RE: Lyons Quarry; DRMS File No. M-1 977-141; Technical Revision No. 2; Responses to DRMS Comments in Adequacy Review No. 4;

AGGREGATE INDUSTRIES LYONS QUARRY RECLAMATION PROJECT

#### EXHIBIT F RECLAMATION PLAN MAP PREPARED MAY 10, 2017

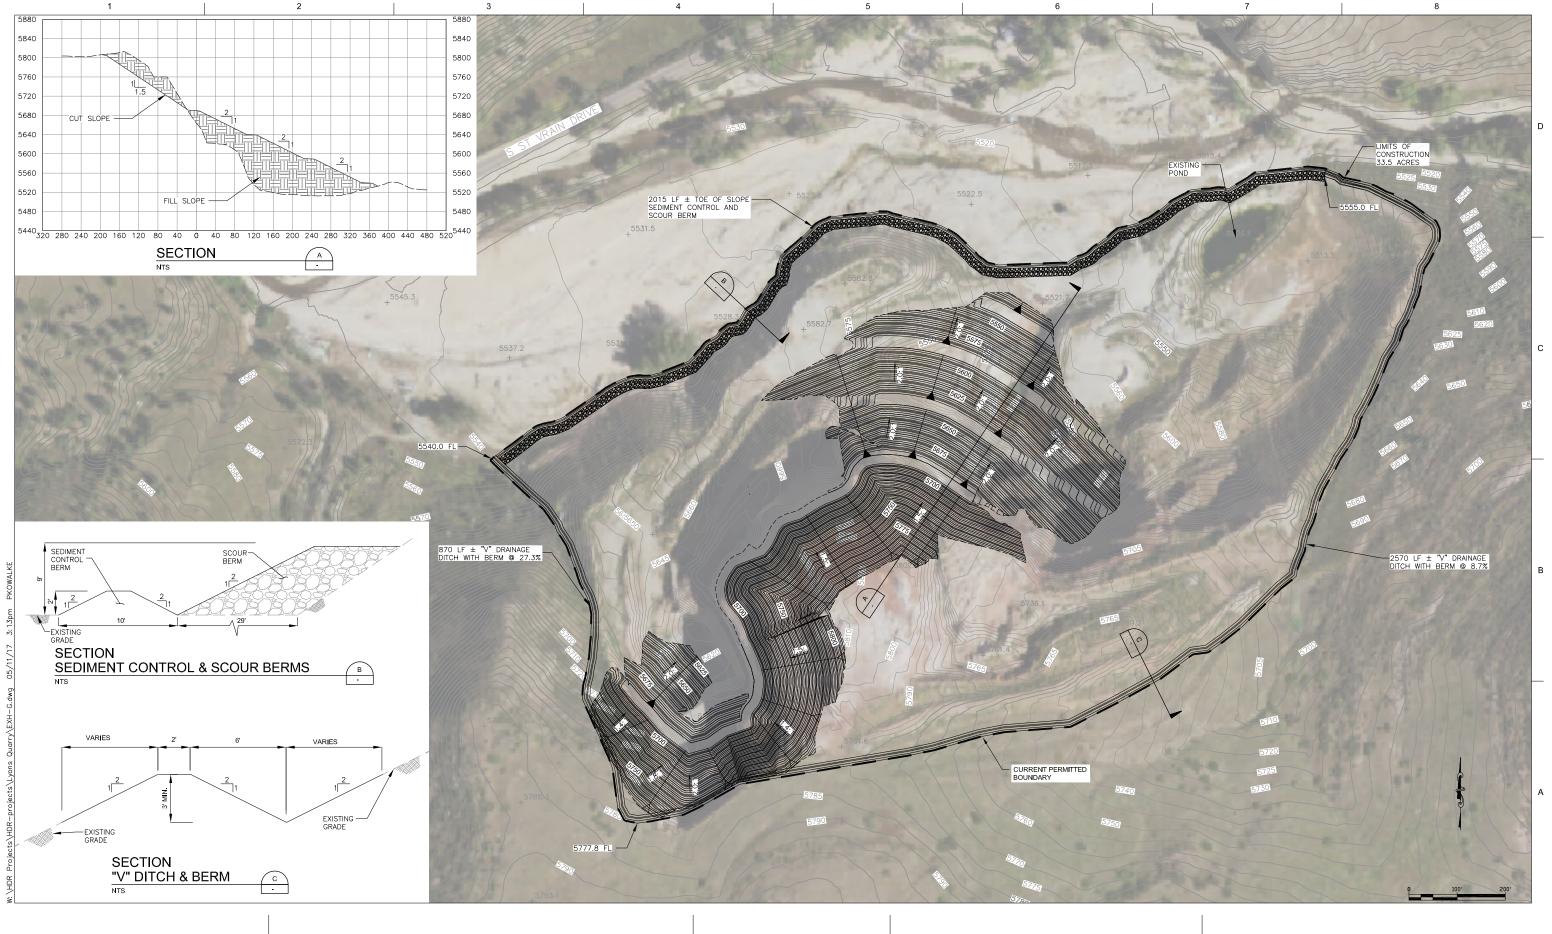
The Reclamation Plan Map outlines an area of 59.6 acres. The Reclamation Plan Map must be revised to depict the entire area which corresponds with the permit area of 71 acres. Please reference the Reclamation Plan Map which was submitted under Amendment No. 2 for the most recently approved permit boundary configuration.

Exhibit F – Reclamation Plan Map is revised to depict the entire area corresponding to the71 acre permit area submitted under Amendment No. 2.
